SUBJECT: Marion Road Trunk Sanitary Sewer Alternative Areawide Review and Mitigation Plan
Final Update #1

Marion Road Trunk Sanitary Sewer Project
Rochester, MN

Alternative Urban Areawide Review
and Mitigation Plan
Final Update #1

Figure 3

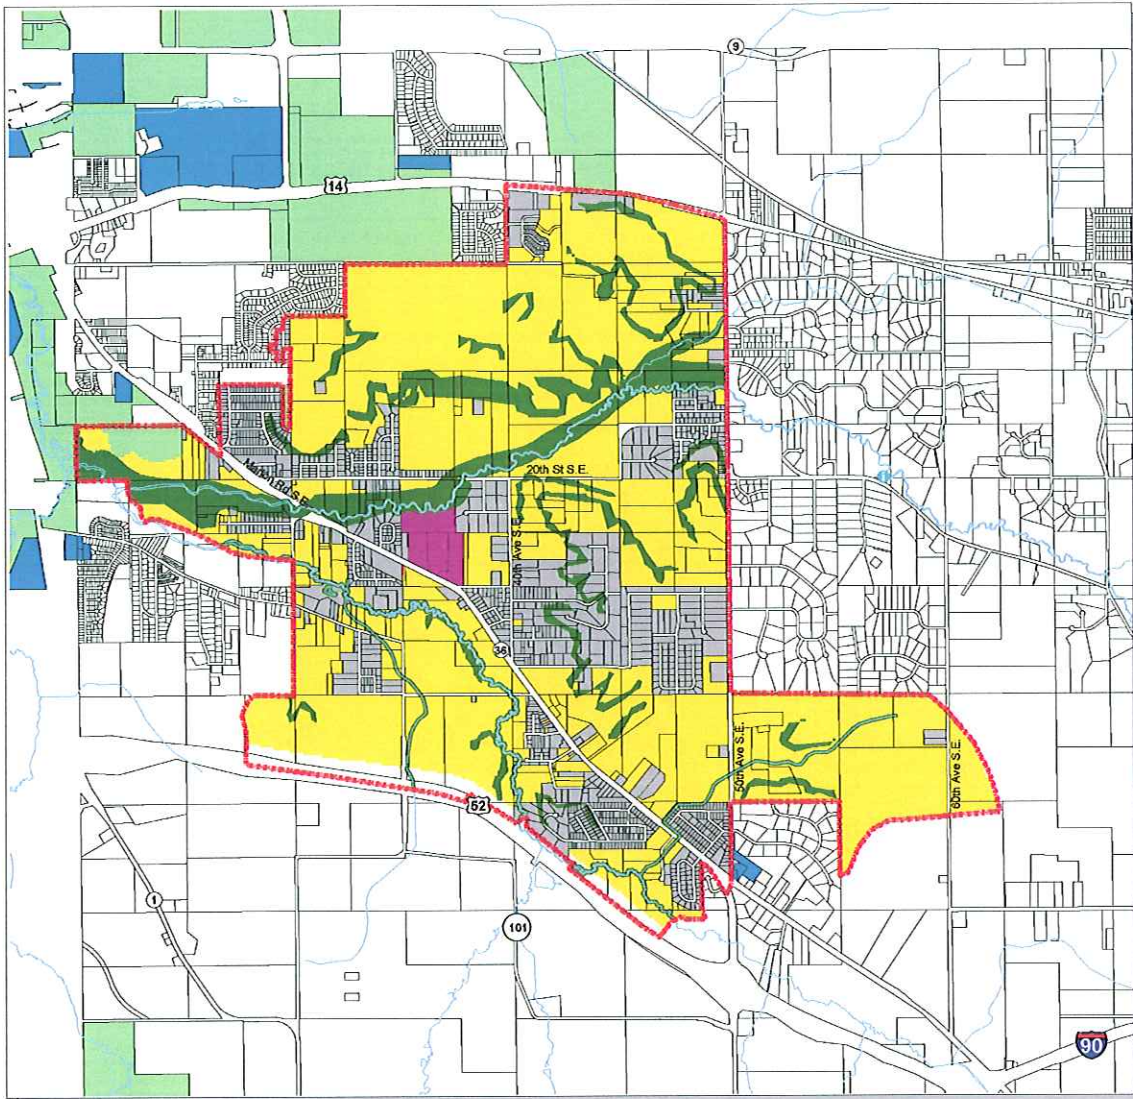
Copies of the comments and the responses to comments are included in Appendix B of the revised Final AUAR Update #1. Modifications were made to the Final AUAR Update #1 to address the comments. The most significant revisions were included in Items 11 (wildlife) and 17B (storm water). Minor clarifications were incorporated in Items 4, 6, 9, 10, 12, 14 and Part II. Due to these revisions, page numbers were updated in the Table of Contents. Also, the original Figure 3 inadvertently incorporated the zoning map instead of the hypothetical development scenario map; this was corrected in the Final Update #1.
